## 2007 No. 311

# The Traffic Signs (Amendment) Regulations (Northern Ireland) 2007

#### **Amendments**

Parking place for permit holders with limited waiting permitted by others at specified times (Alternative types)

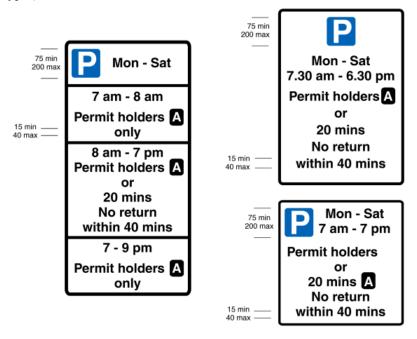
- (f) for diagrams 660.6 and 660.7 and the words specified in and under them there shall be substituted the diagrams and the words specified in and under them specified in Part II of the Schedule;
